**CITY OF CARPINTERIA
ARCHITECTURAL REVIEW BOARD
Meeting of September 14, 2023**

**COMMUNITY DEVELOPMENT DEPARTMENT
PROJECT REVIEW**

Project: 22-2183-CUP/CDP/ARB
Address: 5557 Calle Arena
APN: 003-382-011
Zoning: Single Family Residential (6-R-1)
Applicant: Ted Meeder, architect, for Tyler and Jessica Mayer

Mayer Residence Remodel and Additions
Project #22-2183-CUP/CDP/ARB
Preliminary ARB Review
September 14, 2023

PROPOSED SECOND FLOOR PLAN

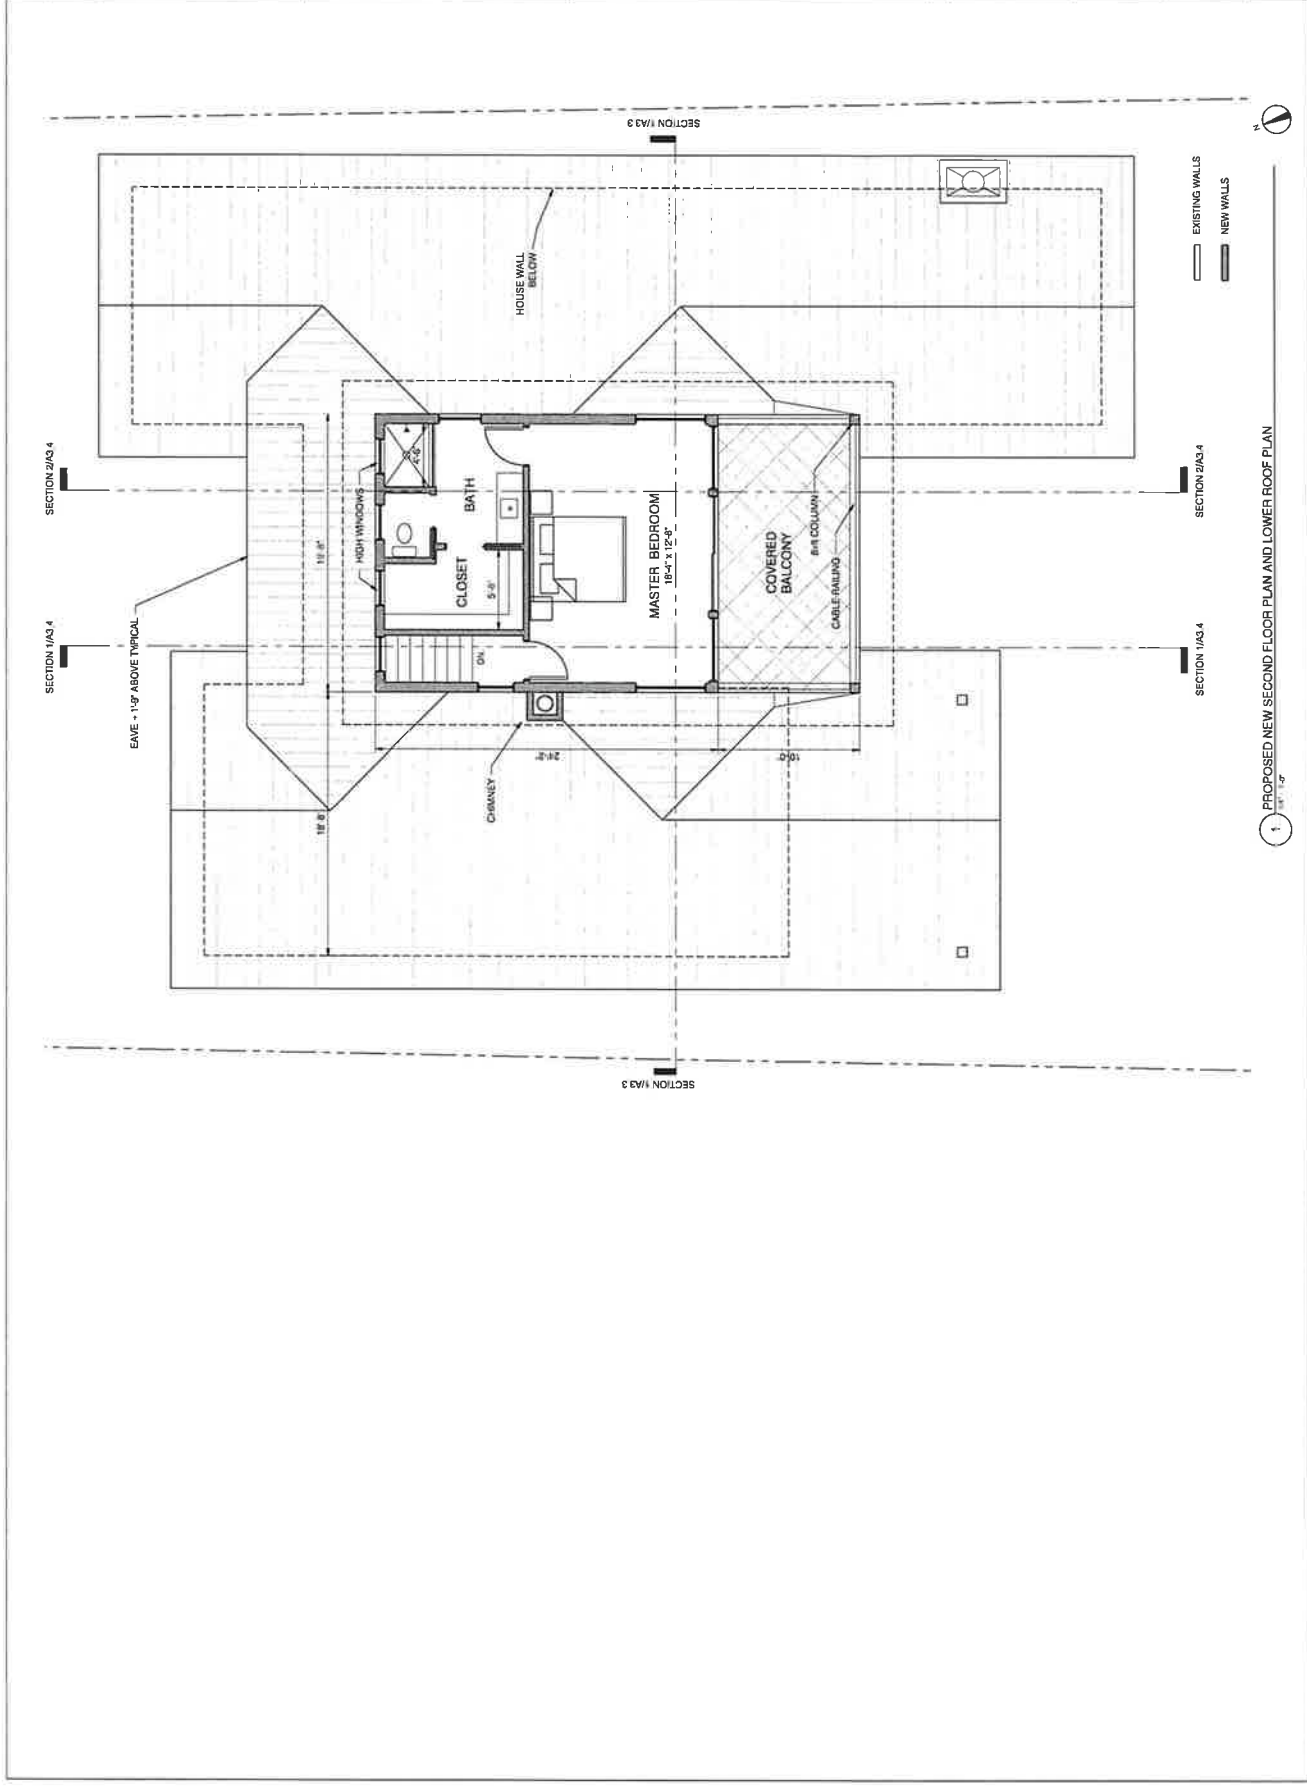
Given the predominant single-story character of the area, and the historical controversy over two-story homes in this neighborhood, the height, size, and massing of the proposed second-story addition is a concern to staff. **The Board should comment on the height, size, and massing of the preliminary design for the project.**

The project design with the relocated entry and new landscaping and hardscape improvements in the front yard would enhance the street presence of the residence. However, as mentioned above, the height and prominence of the second story portion of the proposal would be out of character with other homes in the area. The proposal could be revised with lower plate heights or other design alterations to become more compatible with the other existing two-story homes in the neighborhood. A revised design could also explore an expanded single-story design, which could further reduce or eliminate the second story altogether.

EXISTING AND
PROPOSED
ELEVATIONS

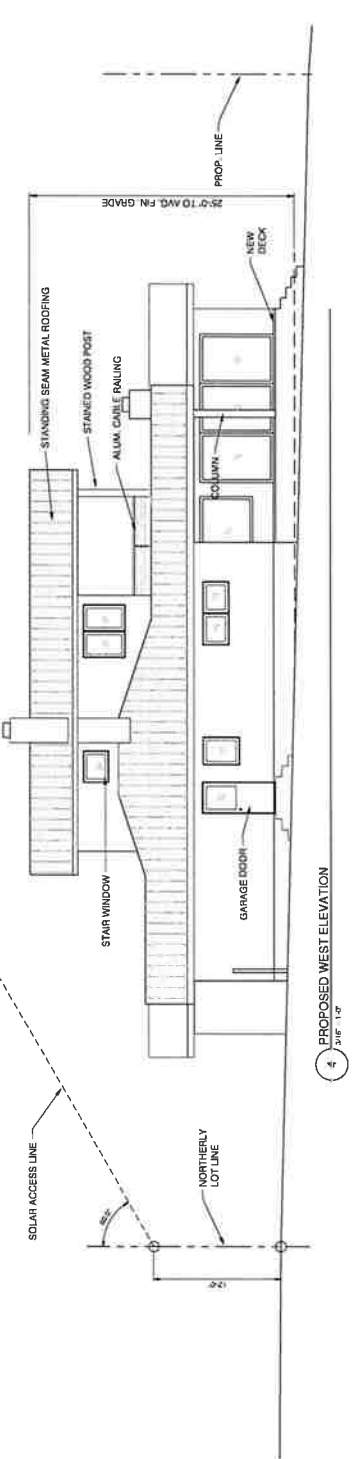
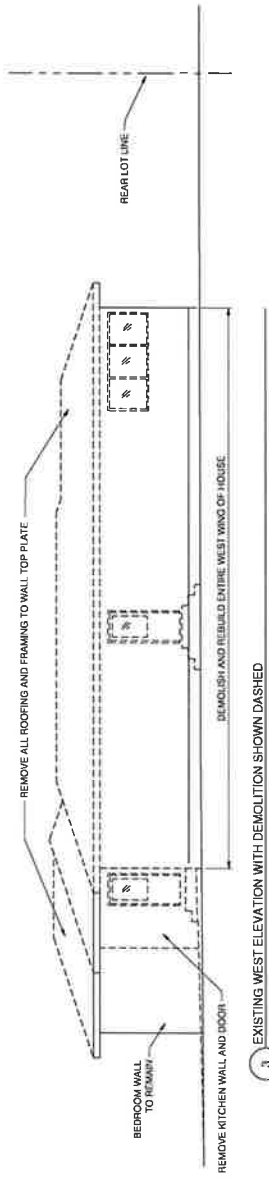
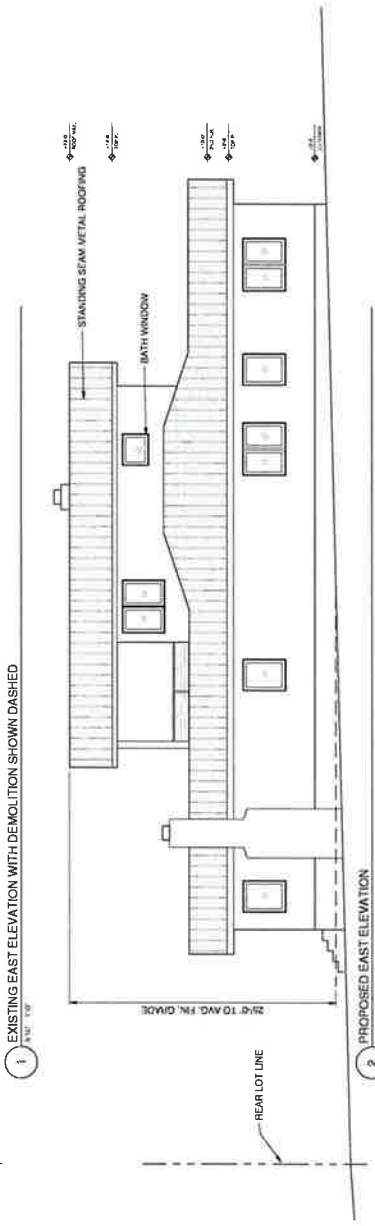
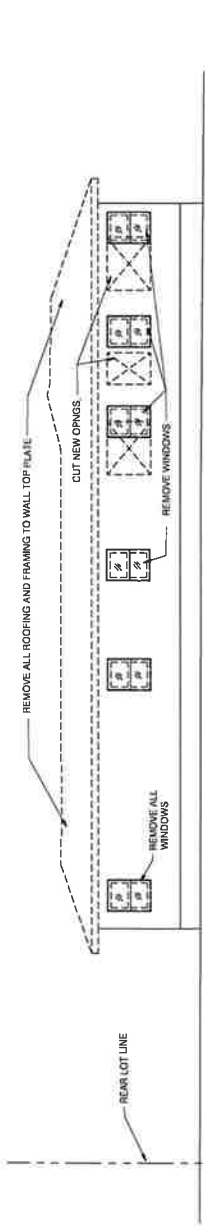
by the City, continues to be controversial. On recent past projects, significant effort has been put into trying to minimize the visual prominence of new two-story construction through careful placement, massing, and use of split level plans and topography, in an effort to preserve the largely single story character of the neighborhood. The current proposal concentrates the second-floor mass over the center of the residence in the preferred “wedding-cake” manner, however the height would likely result in a visually very prominent second story mass.

Portions of the existing residence which would be significantly remodeled/reconstructed are set back 20-feet from the street, which is comparable to the setbacks of other older homes in the neighborhood. The proposed two-car garage addition would be set back 25-feet from the street, which complies with the current zoning requirements and would be consistent with other newer development in the area. The proposed second story would be centered over the residence with single-story elements surrounding it on three sides, but could become more “nestled in” with lower plate heights or other design alterations.
